CITY OF BOULDER
PLANNING BOARD MEETING AGENDA
DATE: September 4, 2014
TIME: 6 p.m.
PLACE: Council Chambers, 1777 Broadway

- C. CONCEPT PLAN REVIEW AND COMMENT: Request for citizen, staff and Planning Board comment on a proposal to redevelop the existing properties located at 3085, 3155 and 3195 Bluff Street** totalling approximately 4.25 acres into 77 dwelling units consisting: 24 three-bedroom, for-sale townhomes; 45 two and three-bedroom permanently affordable rental townhomes; and eight standard townhomes. Total of 84,534 square feet of habitable area on three lots: 3085, 3155 and 3195 Bluff Street. Review case number LUR2014-00050.

3 Landscape Concept Plan
1" = 10'-0"

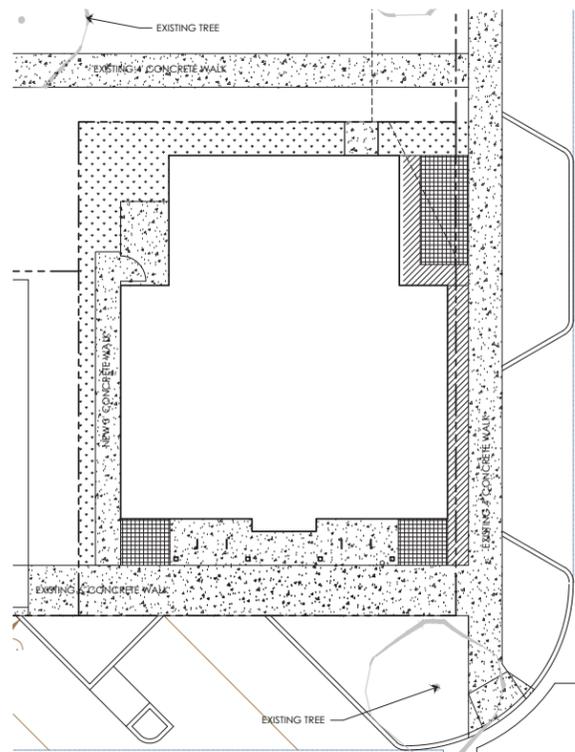
Portions of the proposed water quality swale have been called out as rock mulch on the Landscape Concept Plan on Sheet SR-2. A rock mulch swale is not considered to provide water quality treatment; alternate materials should be selected for this location. Please review the Urban Storm Drainage Criteria Manual – Volume 3 for water quality treatment design alternatives.

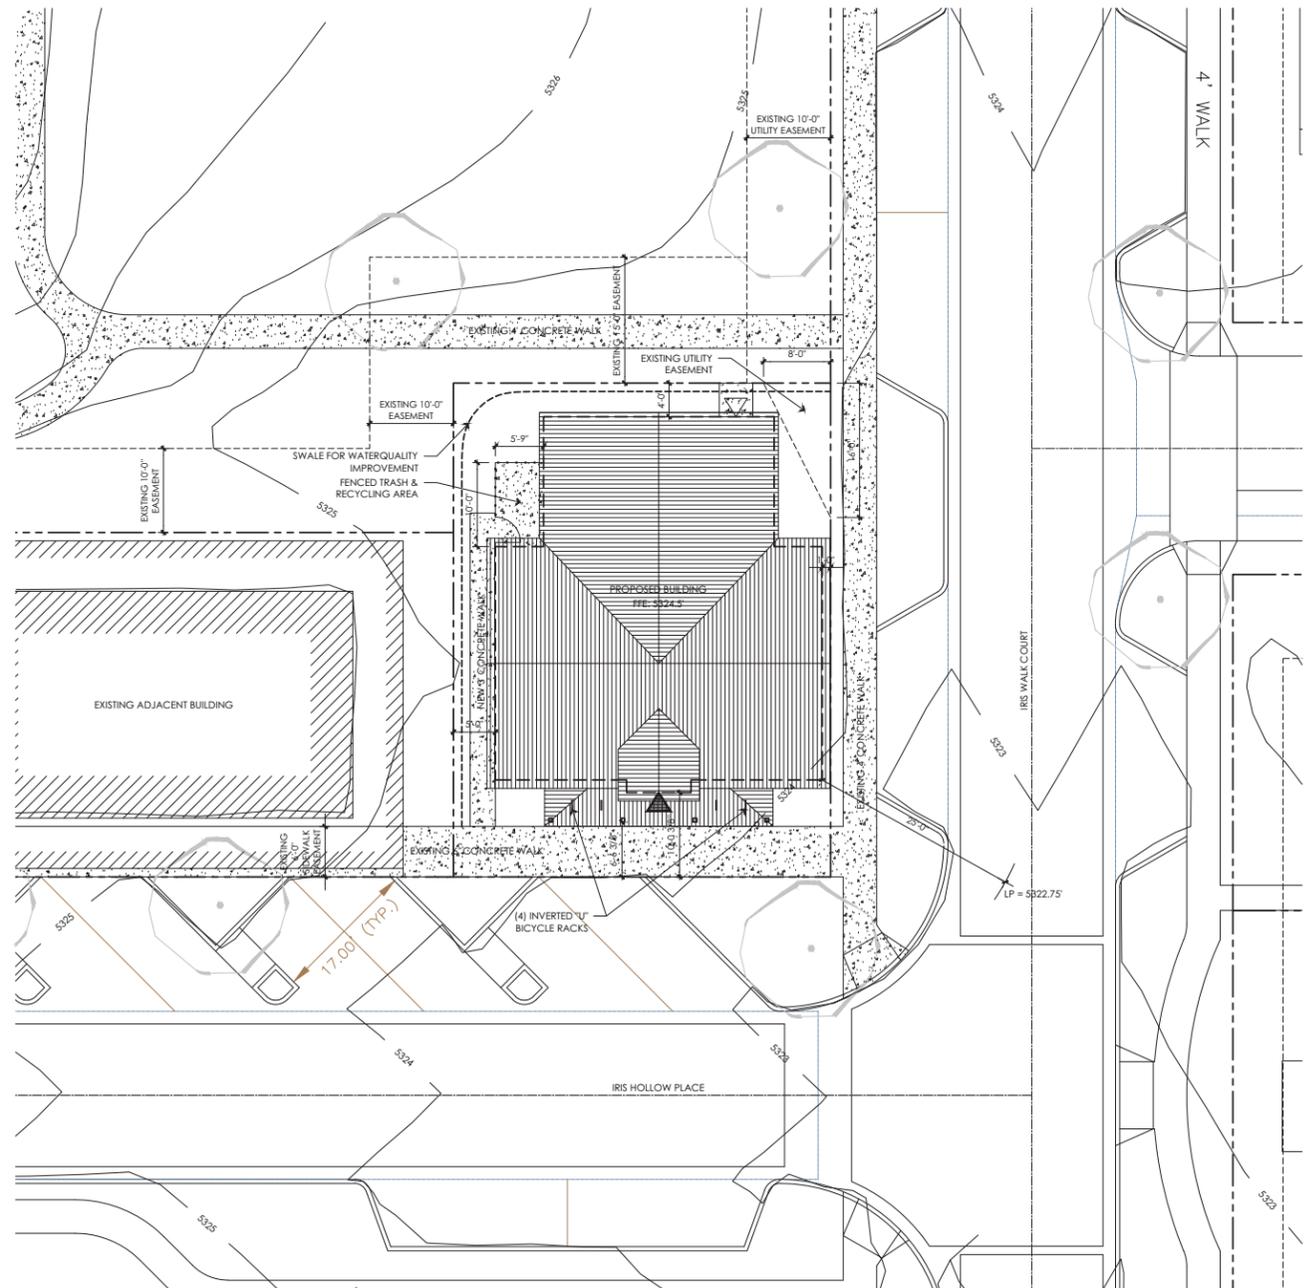
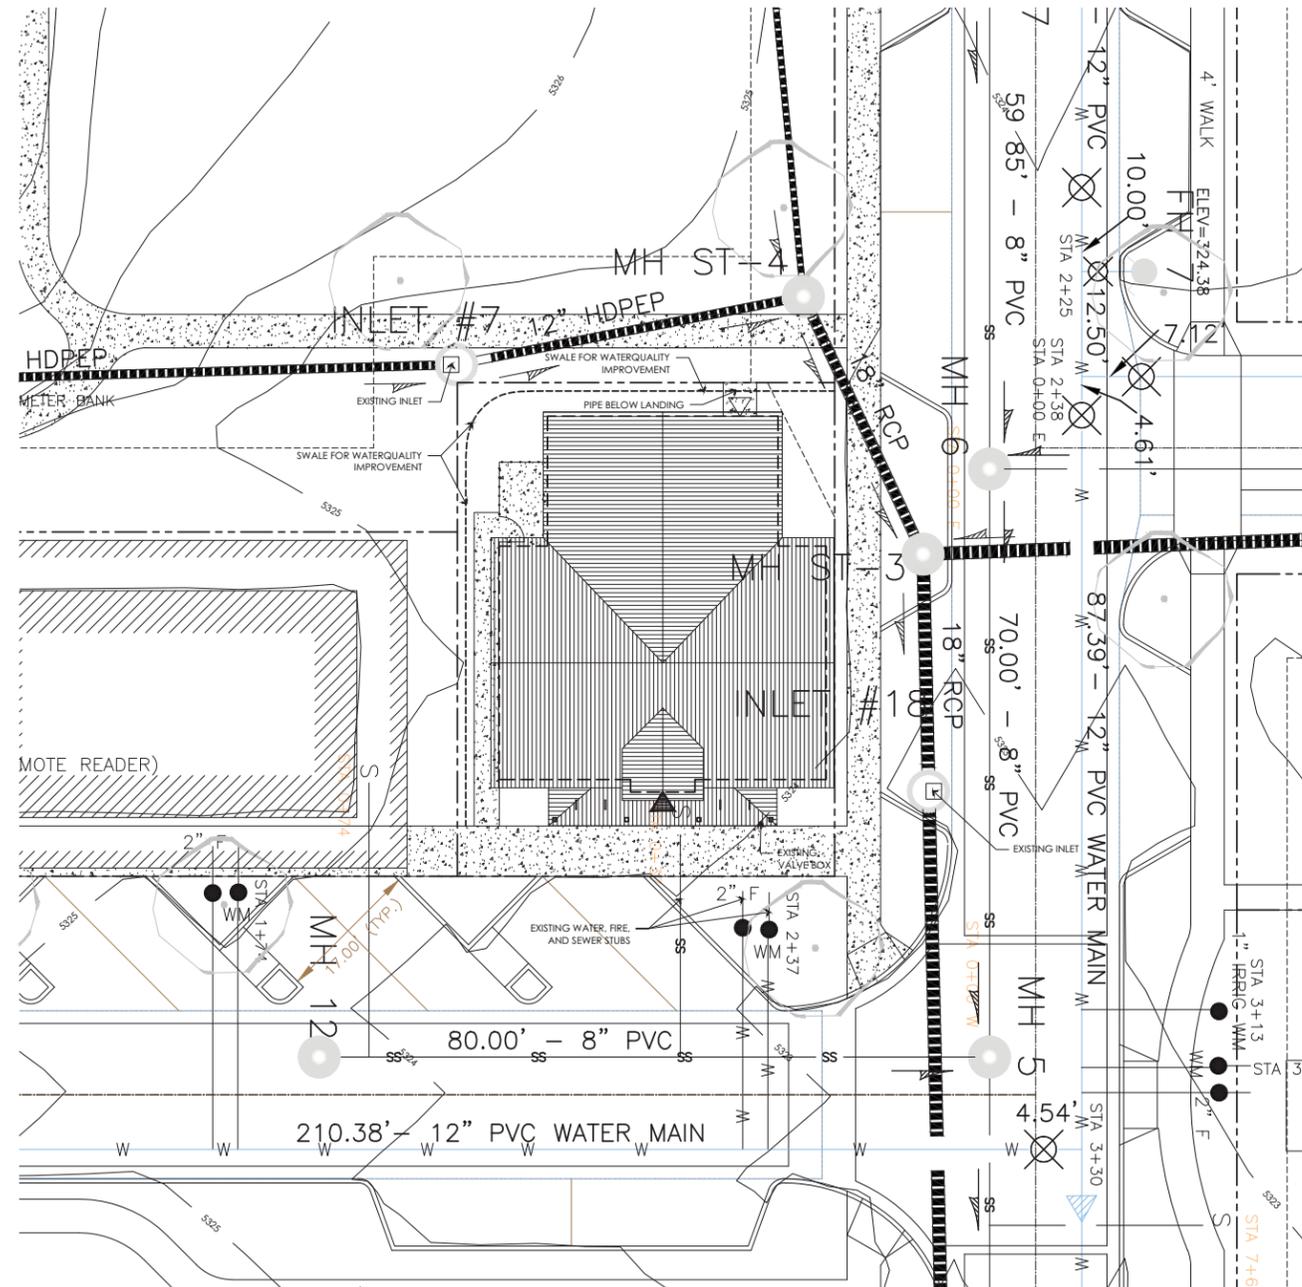
4. Consistent with technical drawing 2.21 of the City of Boulder Design and Construction Standards (DCS) a skewed driveway ramp is not permitted. Please revise plans to meet technical drawing 2.21.

The applicant will be required to comply with Sections 7.12 - Detention and 7.13 - Storm Water Quality of the City of Boulder Design and Construction Standards. Please revise the Utilities & Drainage Plan, Sheet SR-3 to demonstrate how the proposal will address these requirements.
